PANEL REFERENCE & DA NUMBER	PPSHCC-137 DA2022/00538
LGA	City of Newcastle (CN)
PROPOSED DEVELOPMENT	Mixed Use Development - Shop top housing, comprising commercial premises (4), carparking (171), podium level, and residential (106) units.
STREET ADDRESS AND OWNER DETAILS	Lot: 1 DP:1166015 643 Hunter Street Newcastle West
APPLICANT	ADW
OWNER	Next Level Seven Pty Ltd
DATE OF DA LODGEMENT	20 May 2022
APPLICATION TYPE	Local
REGIONALLY SIGNIFICANT CRITERIA	<p>The application is referred to the Hunter and Central Coast Regional Planning Panel ('the Panel') as the development is 'regionally significant development', pursuant to Section 2.19 and Clause (2) of Schedule 6 of the State Environmental Planning Policy (Planning Systems) 2021 as the proposal is a general development that has a capital investment value of more than \$30 million.</p> <p>The application submitted to Council nominates the capital investment value of the project as \$49,590, 708 (excluding GST)</p>

This supplementary report provides further information in response to matters raised during the determination meeting and provides associated amended conditions of consent. The supplementary assessment should read in conju

Figure 1: Concept Waste Plan – Ground Floor

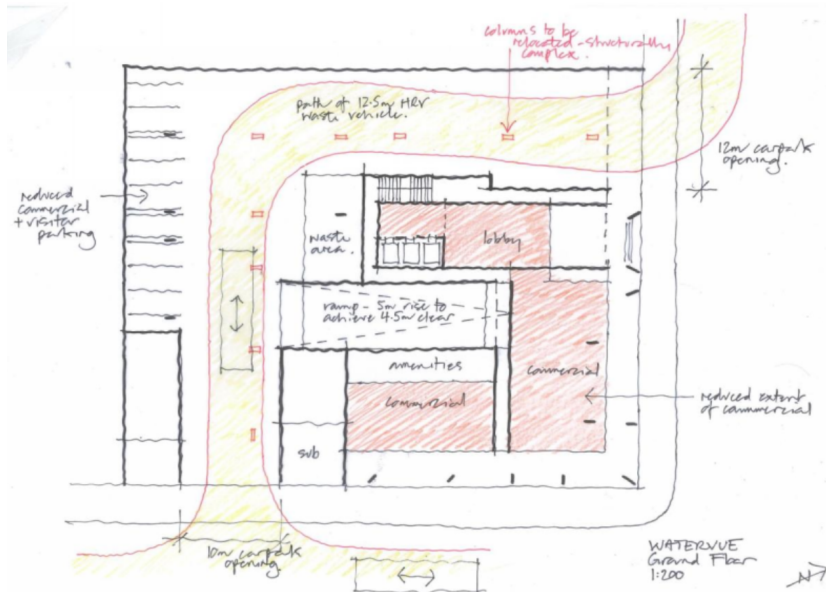
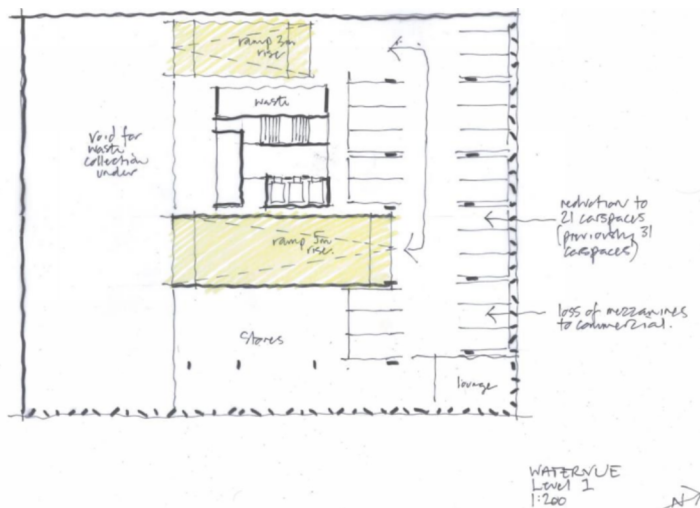
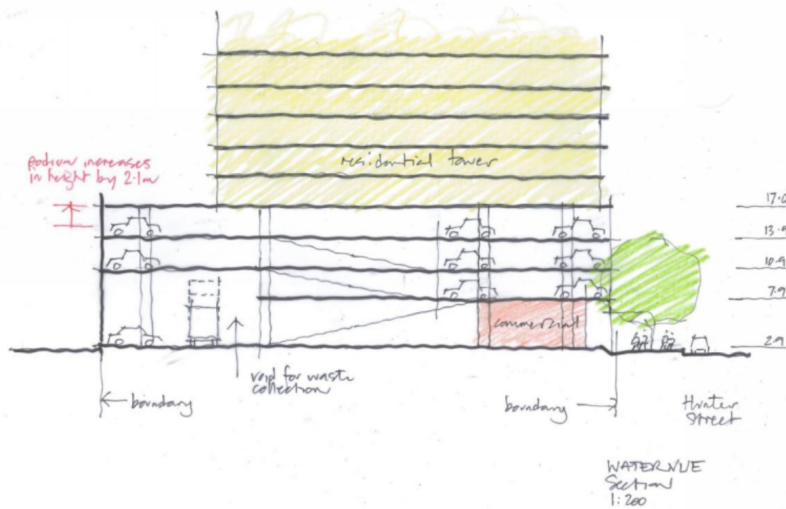
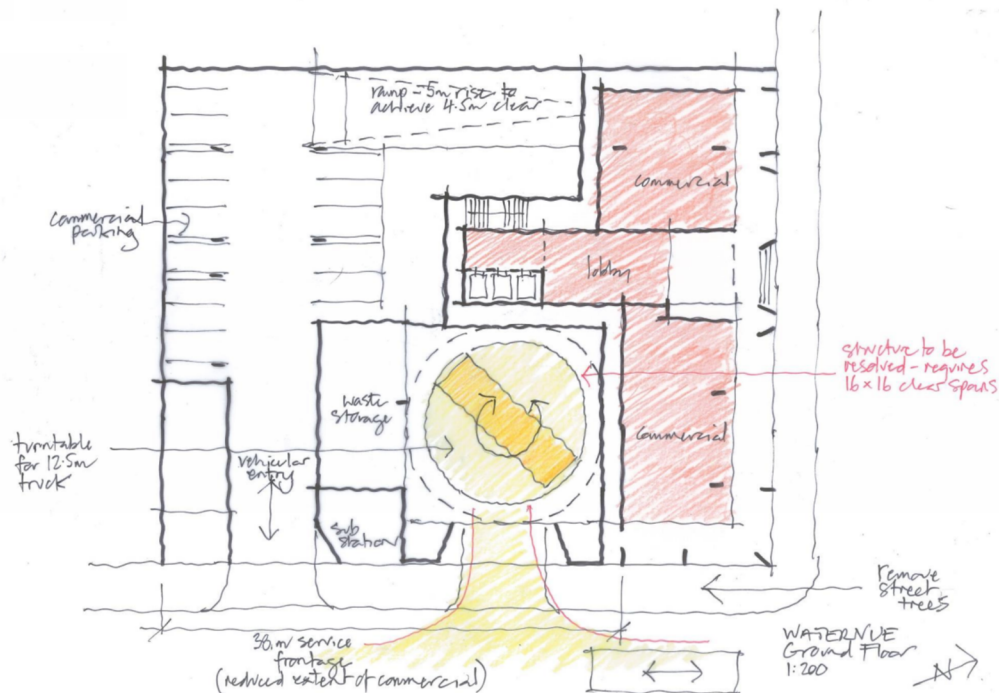
If on-site waste servicing is the only means of waste servicing at this site, the design must accommodate servicing by Council's waste collection due to the levying of the Domestic Waste Management Service Charge on residential property. Council's waste collection fleet consists primarily of the AS 2890.2:2018 Heavy Rigid Vehicle (HRV) class of truck (length: 12.50m length, width: 2.5m, design turn radius: 12.5m). Due to the 12.5m design turn radius, a large turning area on the ground floor would be necessary to allow the HRV to enter and exit the development in the forward direction.

This would significantly diminish usable commercial floor area, which would impact on the overall streetscape along Hunter and Steel Street and limit street activation.

A turntable loading area provides a more space efficient alternative to allow HRV servicing however the area must be separated from resident/visitor traffic to the development. A separated vehicular crossing is necessary off Steel Street or Hunter Street. As is demonstrated in a concept sketch by the Applicant, this option also significantly diminishes commercial space, car parking and reduces street activation opportunities. Any additional driveway crossings on Steel Street would also conflict with a planned on-road cycleway along the west side of Steel Street, and the combined width would result in a 14-metre sterilisation of the public domain to accommodate the two separate driveways. This option is not supported by Council given the significant impacts on the public domain, anticipated cycle network, and reduced street activation opportunities.

The solution is a proposed Loading Zone along Steel Street that will be time restricted to off-peak hours to provide additional storage in the left turn lane during peak traffic. This Loading Zone (see attached sketch) has been rationalised with the West End Streetscape Plan for Steel Street.

The proposed solution has been reviewed by the Newcastle City Traffic Committee (NCTC) and is largely supported. It is noted that the NCTC identified that key details of the proposal, including the storage capacity of the left turn lane for bus movement would be resolved during the detailed design stage of the Section 138 Road Application.

Figure 5: Drawing Number DA103 – Parking level 2

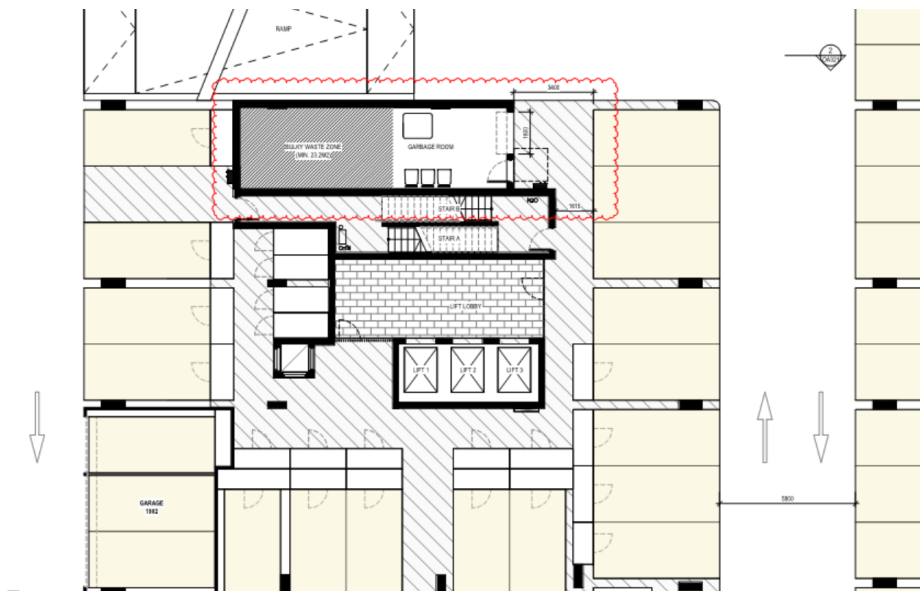
- (iv) *What parking restrictions are required to facilitate the waste management solutions as proposed.*
- (v) *Identification of a bulk store area located within the parking areas.*

Bulk Storage Area

The applicant has amended the plans to include a bulk waste storage area located on parking level 2 as shown below at figure 5. To accommodate the new waste area the applicant has removed a tandem parking space and reduced the size of the previous storage cage. The proposed bulky waste area can accommodate large items that may need to be stored and removed. The removal of the car parking area and larger storage cage does not impact the proposals compliance with car parking or GFA.

Figure 6: West End Streetscape – Stage 2 Plan.

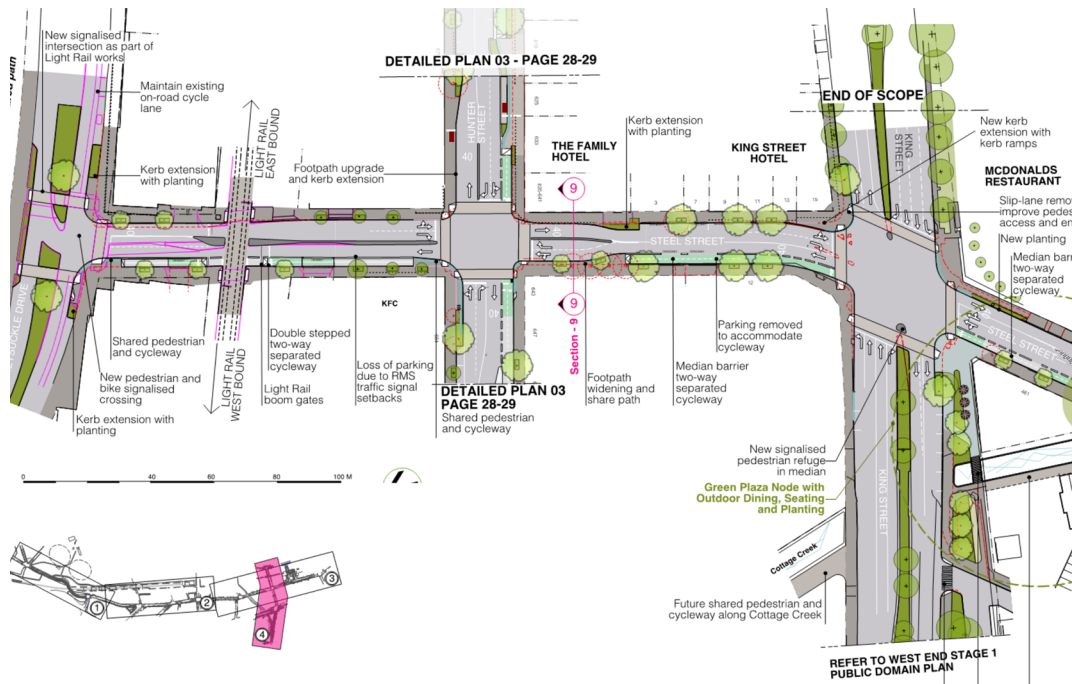
- (ii) *The proposed cycleway along Steele Street and whether this will impact upon on-street waste pick up.*
- (iii) *Details of the proposed cycleway work, whether it is programmed and how these impacts upon street trees and public domain works.*

Proposed cycleway network and waste pick up on Steel Street

The proposed cycleway will merge onto the footway, which is to be widened as a Shared Path, prior to the Loading Zone. The proposed cycleway and shared path will not impact upon collect-and-return waste servicing from the future Loading Zone. Figure 6 and Figure 7 identify the anticipated west end streetscape plan and an indicative loading bay area that will be subject to detail design at the Section 138 stage.

Figure 7: Draft sketch of possible loading bay location – which considers the proposed cycleway network.

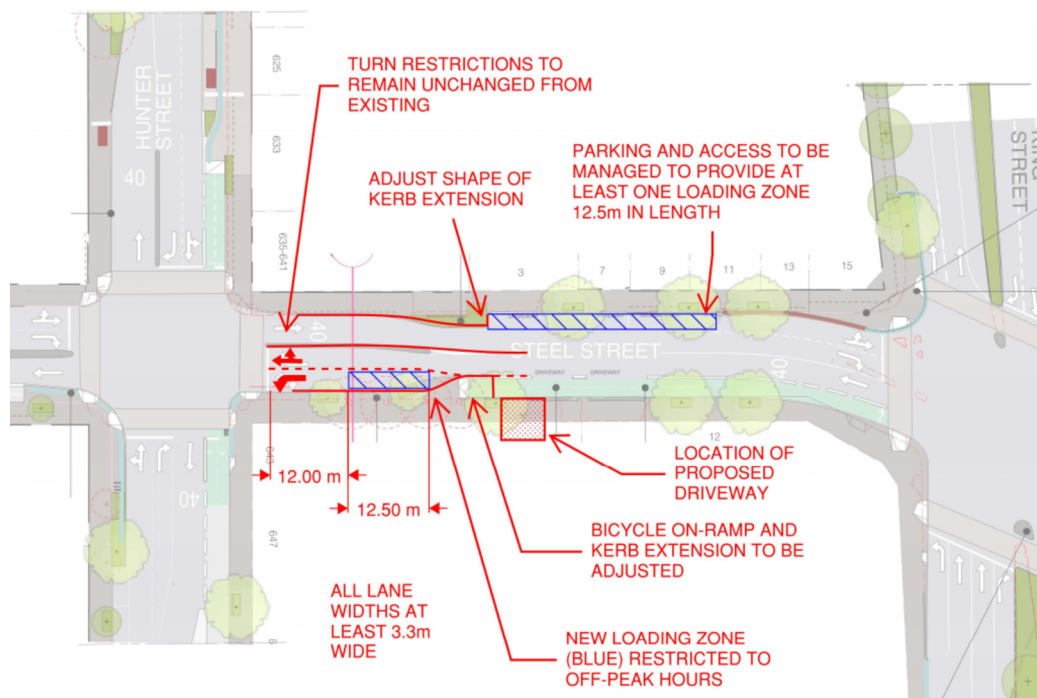
Proposed cycleway network and the public domain

It is understood that the works are not yet scheduled into the Council's Capital Works Program, however, further discussions with both Council's Traffic and Transport and City Infrastructure Team have confirmed that the cycleway is anticipated to be accommodated along the west side of Steel Street.

Whilst there are no detailed design plans available, it is expected that the cycleway will be implemented generally in accordance with the West End Streetscape Plan, necessitating removal of 4 existing mature London Plane Street trees to facilitate the shared path. As shown in Figure 7 the proposed loading zone can be accommodated outside of the shared cycleway, and do not compromise the anticipated public domain works.

Figure 9: Site Plan from feasibility study - identifying the proposal, Travelodge building, existing Travelodge car park and a portion of the Verve development (Page 5).

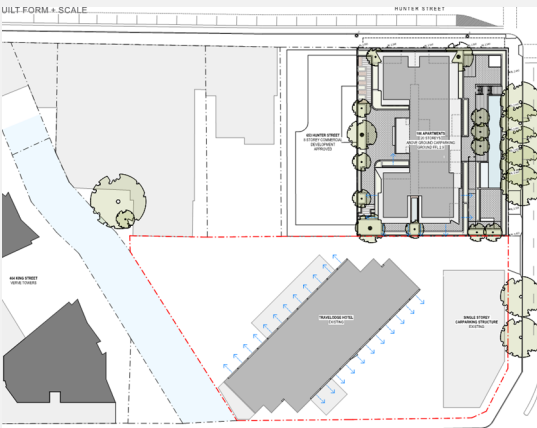
- (viii) *An analysis of the arguments supporting or otherwise the reduce setback to the Travelodge hotel site.*
- (ix) *Consideration of the design excellence provisions specifically.*

If the proposal were orientated to achieve strict compliance with the ADG the application would likely be positioned in an east to westerly direction. Orientating the proposal in this manner would likely result in the reduced northerly solar aspect, views towards the harbour, and increase privacy impacts on the adjoining Travelodge site.

The applicants have provided a concept feasibility plan for the Travelodge site which provides for a podium level design and two residential towers that can comply with the ADG setbacks. The overall built form of the concept design seeks to take advantage of the city and harbour views and ideal solar access. The breaking up of the residential tower structures in a way mirrors the design of the neighbouring Verve development and continues to respect emerging built form of the West End precinct.

It is considered that the proposed concept development has demonstrated that a compliant ADG design proposal can be achieved and designed in a way that does not compromise the privacy of the subject proposal or sterilise the development opportunities that exist for the Travelodge site.
